Appendix - Shenstone Park Part B Submission

VPA Response to Donnybrook Joint Venture preferred Future Urban Structure (responding to panel direction dated 5th November 2020)

Figure 1 Indicative location of exhibited government school with contours (AHD)

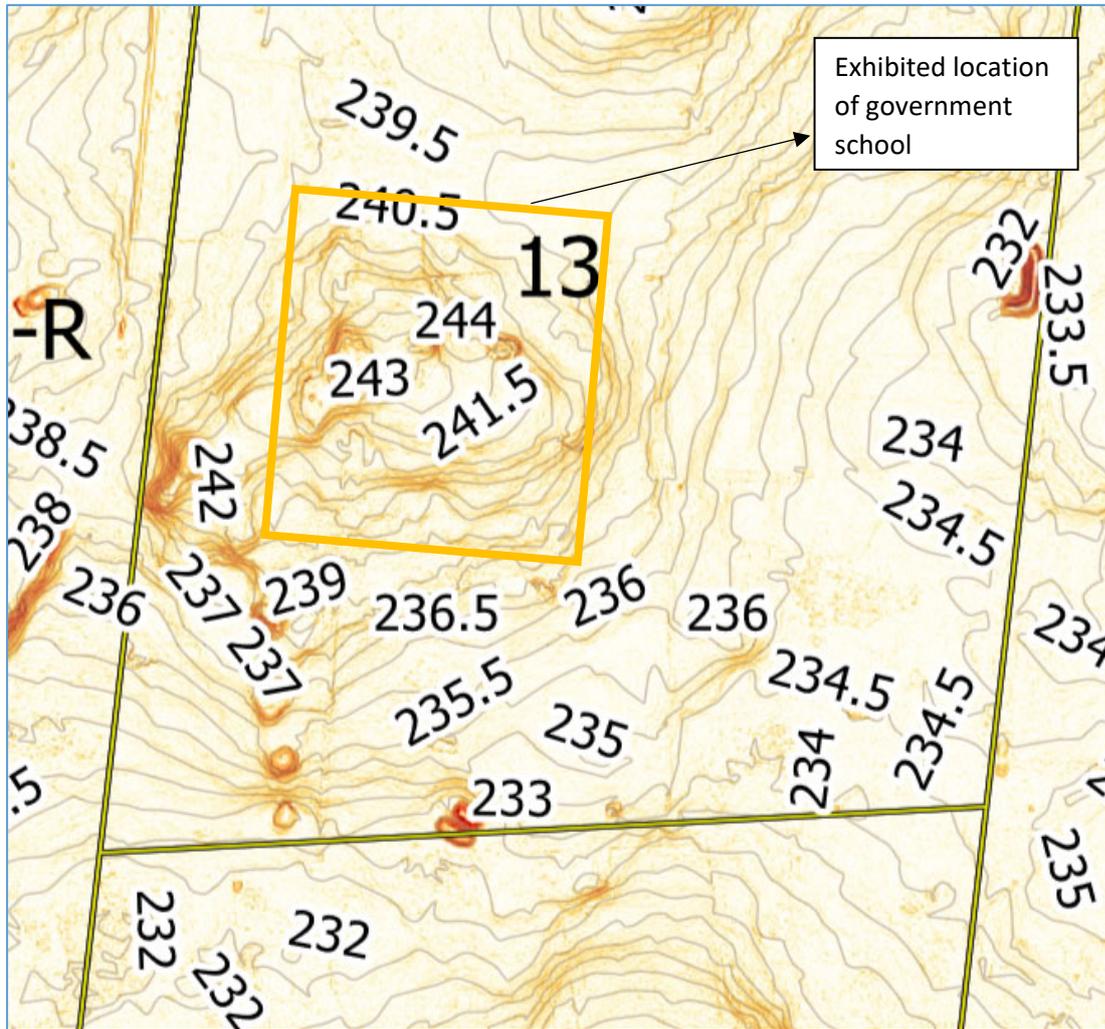
The exhibited school location had a difference of approximately 4m vertical elevation (244m AHD – 240m Australian Height Datum AHD) with the presence of stony knolls across the site (Figure 1). VSBA submitted that the exhibited school location was constrained by topographical and geological

Figure 2 Location of DJV FUS preferred government school (orange shading) with contours (AHD) Shenstone Park PSP

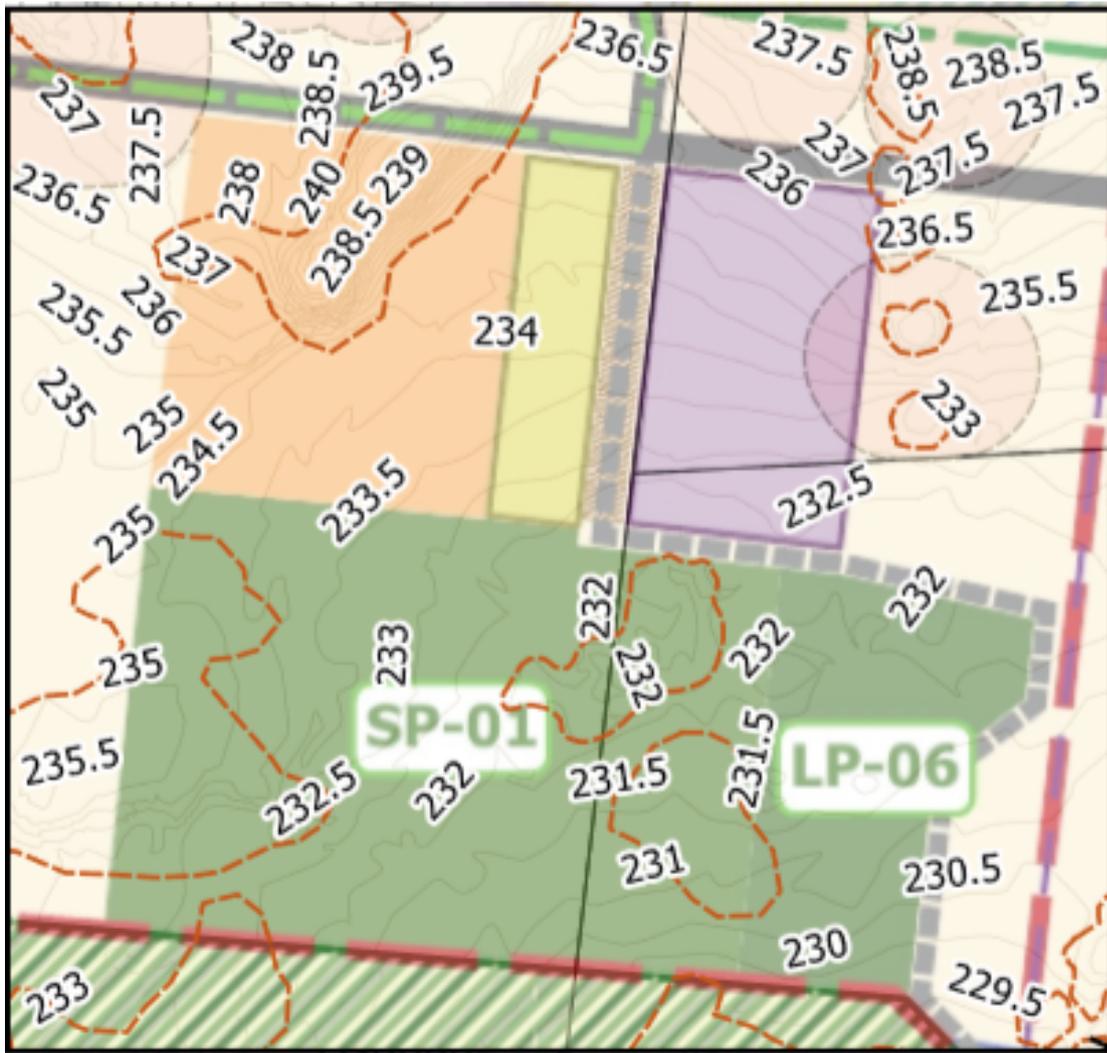
VPA has overlaid the proposed location of the government primary school and community facility in the DJV FUS with available contour information (AHD) at the VPA. Based on contour information, there is a difference of approximately 7m elevation (240m AHD – 233m AHD) across the site (Figure 2). This is approximately 3 vertical metres greater than the elevation difference for the exhibited school location that was considered by VSBA to be unsuitable for the development of a future government school.

In addition to the difference in elevation across the site, the proposed government primary school in the DJV FUS also shows a large stony knoll on the northern side of the site (Figure 2). The red shading in Figure 3 represents slopes >20%. It is clear from Figure 3 that the central and northern areas of the site would require extensive earthworks to provide usable space for school buildings – let alone a flat playing field.

Figure 3 DJV FUS Location of school and community facility with overlay of slope (red shading >20% slope, orange shading 10-15%, yellow <5%)

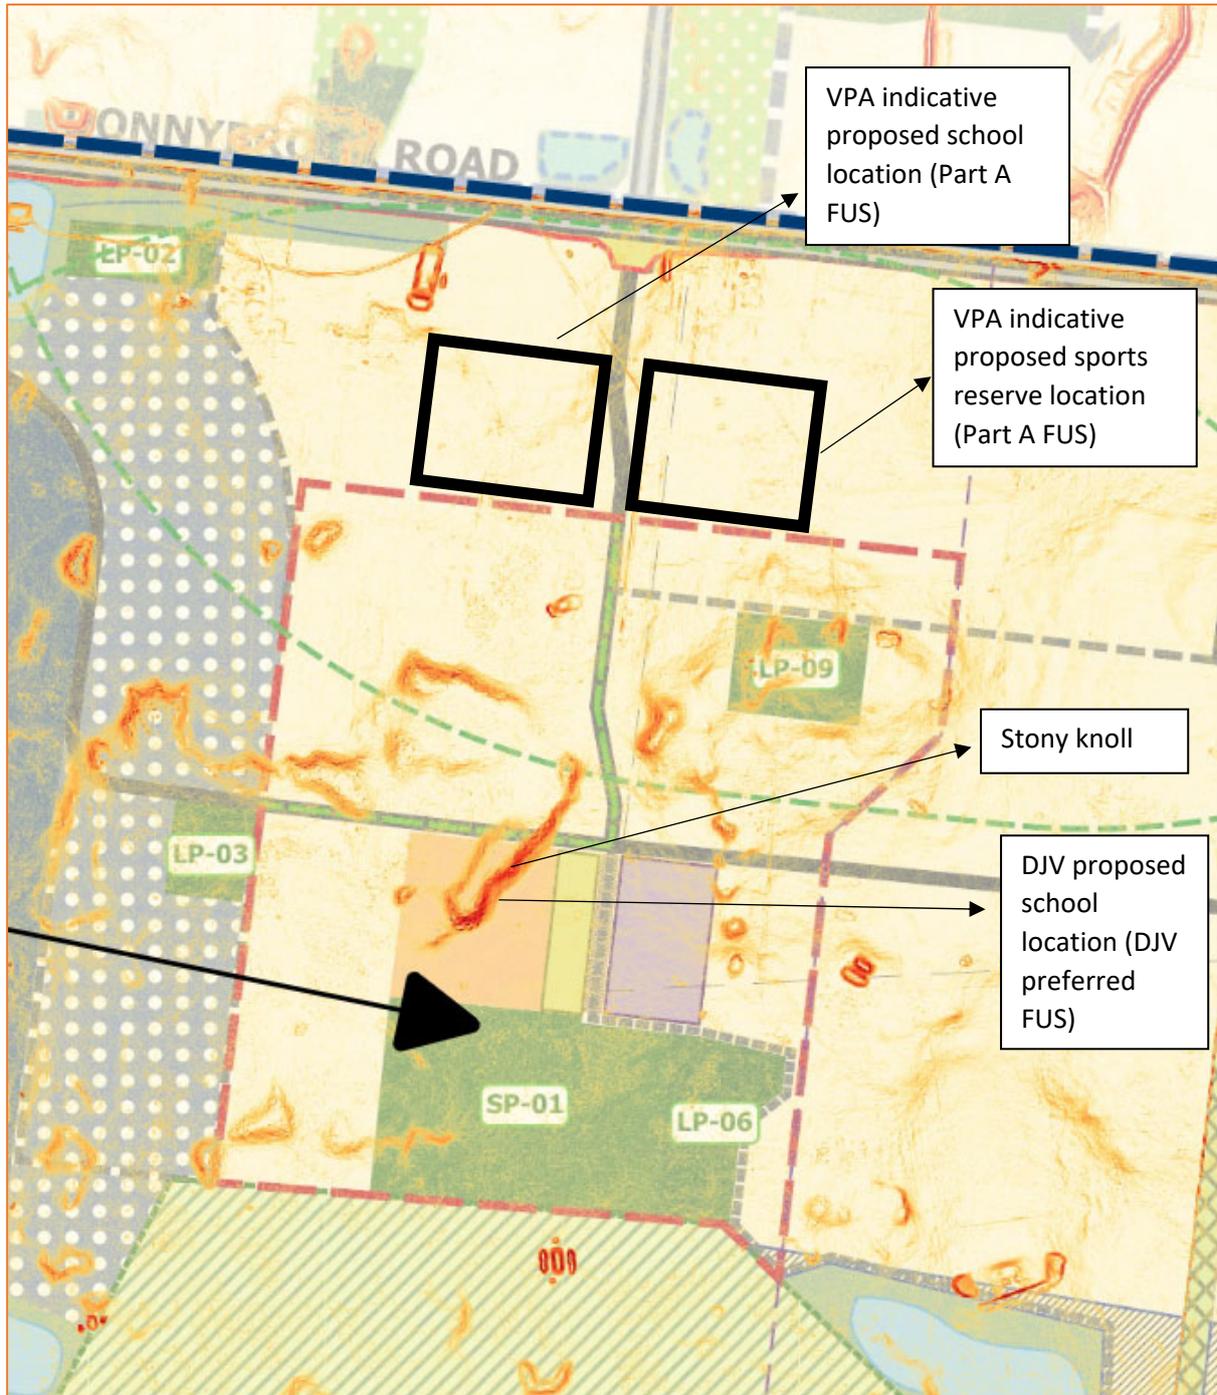
It is likely the location of the government school (DJV preferred FUS) would require significant earthworks (including disposal of rock) to construct buildings and facilities. VPA does not believe it is appropriate to increase the future delivery cost of community infrastructure by siting the school on a site with additional physical constraints compared to VPA proposed location (shown in VPA Part A FUS).

local road along the conservation area boundary. If the school and community centre were moved further north (west is constrained by buffers), this would exacerbate the topographical and physical constraints on the DJV preferred government school; as the large stony knoll present extends to the north east (Figure 3).

Figure 4 - DJV Future Urban Structure with 500m, 550m and 600m buffer overlay on the plan

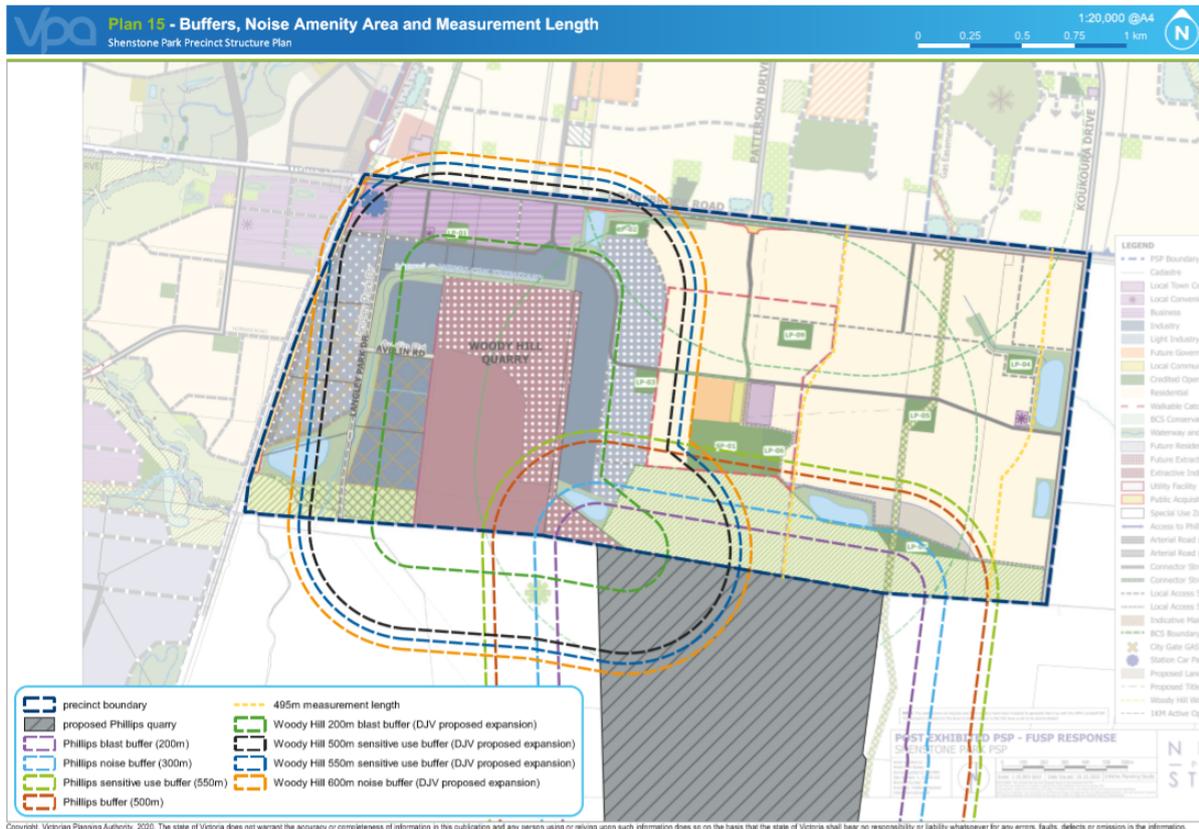
The proposed FUS provided by DJV has expanded the Woody Hill Quarry to the north on 870 Donnybrook Road. While this recognition of the policy support for the quarry expansion is welcomed, there are two key impacts of the proposed northern expansion area based on DJV plan that the VPA considers render this proposal unsuitable being the Sensitive Use Buffer (500 & 550m) and Blast buffer (200m) (Figure 4).

As outlined in VPA Part A submission, there is an existing approved and gazetted PSP to the north of Shenstone Park – Donnybrook Woodstock PSP. Based on a 500m sensitive use buffer from Woody Hill Quarry, the sensitive use buffer would extend into the approved and gazetted Donnybrook Woodstock PSP area (black dashed line). VPA strongly object to any quarry buffers extending into the Donnybrook Woodstock PSP.

Even with the reduced quarry expansion area shown on the DJV FUS, based on a 500m or 550m sensitive use buffer (Figure 4), there is a large area of proposed residential development within the sensitive use buffer (black dashed line). VPA contends it is completely inappropriate to show residential land use within the sensitive use buffer of the Woody Hill Quarry.

In addition to the sensitive use buffer, VPA has applied a noise buffer of 600m which is shown in the buffer plan of the VPA Part A FUS. The VPA has avoided any community uses (including active open space) within a 600m noise buffer of the quarry. It is clear from Figure 4 that the noise buffer extends into the proposed sports reserve in the DJV FUS. VPA believes it is inappropriate to locate active open space within the noise buffer and therefore does not support the DJV proposed plan.

The red and green dashed lines (Figure 4) show an indicative sensitive use buffer located 500 & 550m from the boundary of the Phillips Quarry. It is clear that the sensitive use buffer extends over the sports reserve. VPA does not support sensitive use buffers which extend over the sports reserve.

Figure 5 DJV FUS showing the location of the Walkable Catchment

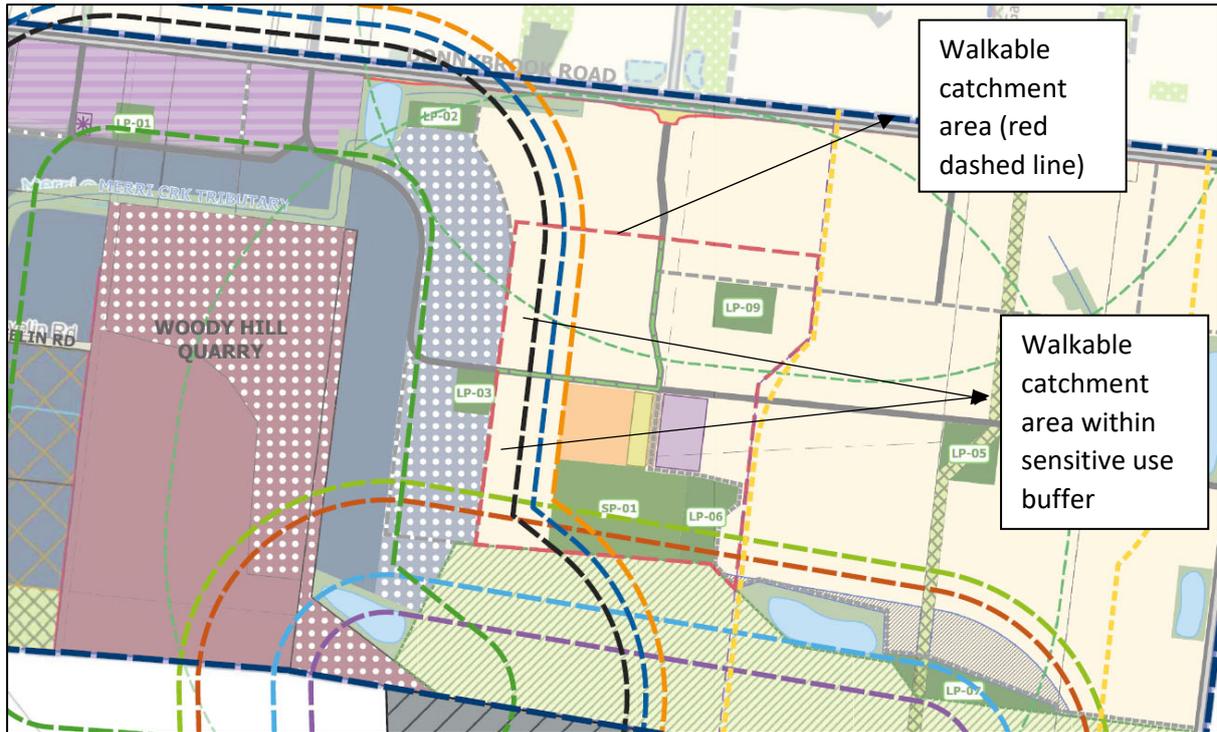
Similar to the extent of residential area contained within a 500m or 550m sensitive use buffer on the eastern side of Woody Hill Quarry, DJV show a significant portion of the walkable catchment proposed within the sensitive use buffer. Based on calculations provided by DJV, there is likely to be approximately 5 ha of walkable catchment land within the sensitive use buffer. VPA contends it is completely inappropriate to show any walkable catchment within the sensitive use buffer of the Woody Hill Quarry.

One of the implications of the walkable catchment is an applied residential growth zone. It is wholly inappropriate to encourage a higher density and built form within a sensitive use buffer from the quarry. It is the VPA’s position that the walkable catchment must be wholly located outside the sensitive use buffer and gas measurement length. Based on a walkable catchment outside all buffers, the figures provided in the ‘preferred FUSP land use budget’ would vary greatly. The DJV FUS proposes a walkable catchment that is highly constrained by buffers. Further, the changes do not substantially increase the area of residential land within the walkable catchment compared to Part A FUS.

Figure 6 - DJV FUS showing the proposed interface of development and Conservation Area 28

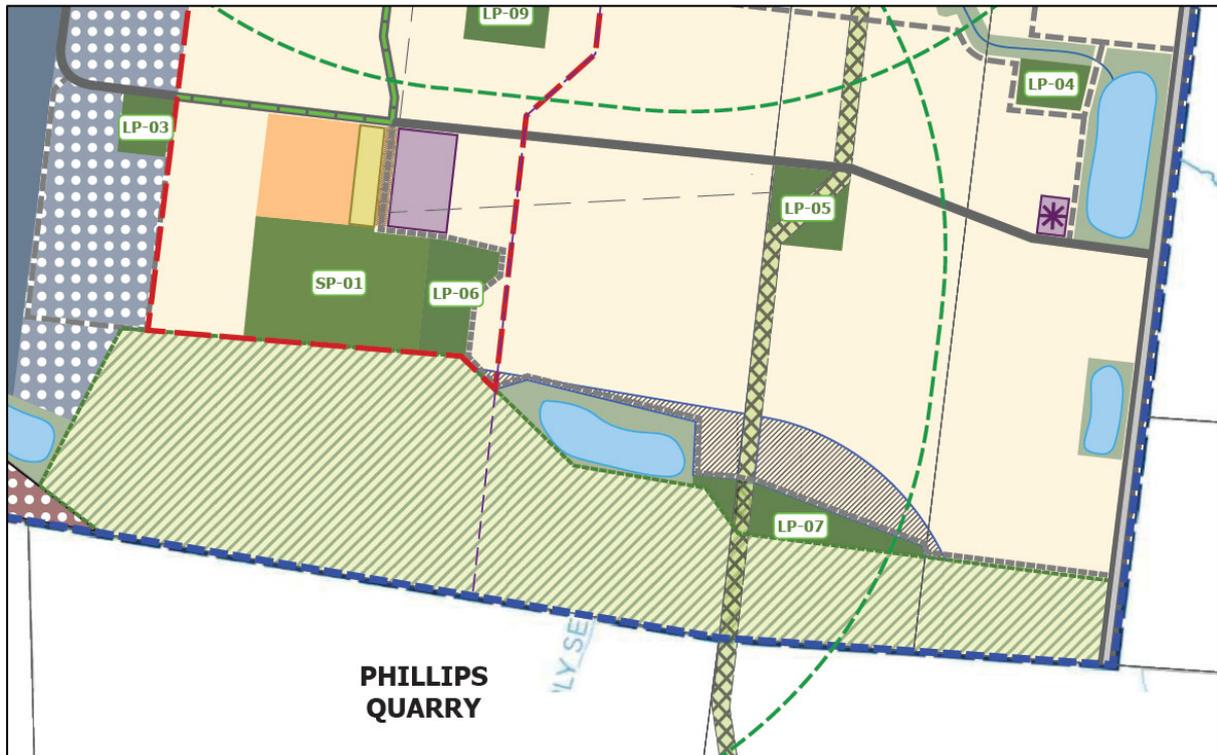
Figure 6 shows the interface between Conservation Area 28 and proposed development. Although partially obscured by the walkable catchment boundary (red dashed line), there is no local road or separation between Conservation Area 28 and the proposed development. That is to say, the boundary local road sought for bushfire safety reasons is absent – as a consequence the separation is lacking between the BCS area and the active open space, and in turn the school, community facilities and town centre. It is unclear how the DJV FUS could be suitably amended to include a

VPA has significant concerns that the interface does not meet current bushfire requirements and DJV has not advanced written evidence that the proposed configuration meets current bushfire requirements.

Figure 7 Contour information (AHD) for 870 and 910 Donnybrook Road

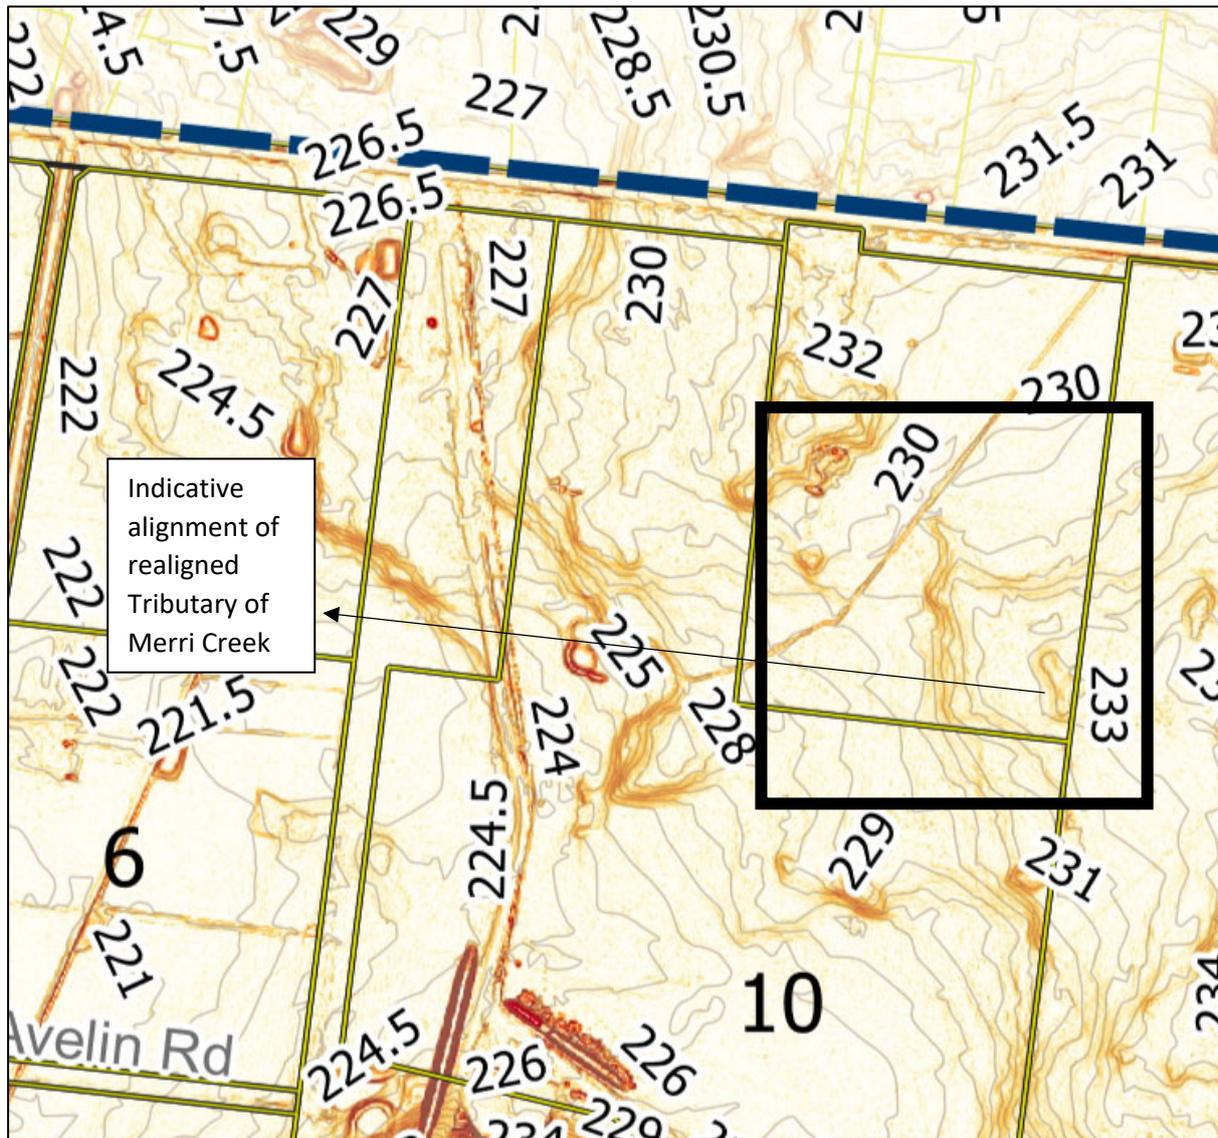
The key problem with moving the waterway into the south eastern corner of the property is that there is an existing high point at approximately 233m AHD elevation. The existing alignment of the waterway is approximately 230m AHD elevation. In order to realign the waterway, a minimum of 3m excavation would be required to in the south eastern corner of 910 Donnybrook Road to ensure the water flows downhill.

Melbourne Water has previously written to the submitter for 910 Donnybrook Road (30 June 2020) to advise that further design would be required to demonstrate the alignment proposed by the DJV FUS could function. VPA has been advised by Melbourne Water that no information has been submitted in support of a revised alignment. Based on topographical constraints and an absence of design by the submitter, VPA believe it is inappropriate to alter the alignment of Tributary of Merri Creek up approximately 3.0 vertical metres through a knoll on 910 Donnybrook Road.

In addition to a conveyance function, there are additional issues with 'cutting' into a hill. Melbourne Water's Constructed Waterway Design Manual provides design criteria including battering to safety on each the side of a waterway. A greater level of 'cut' to the invert of a waterway is likely to require additional battering to achieve the required safety batters. It is inappropriate to show a waterway corridor width without factoring the increased waterway battering through the south eastern corner
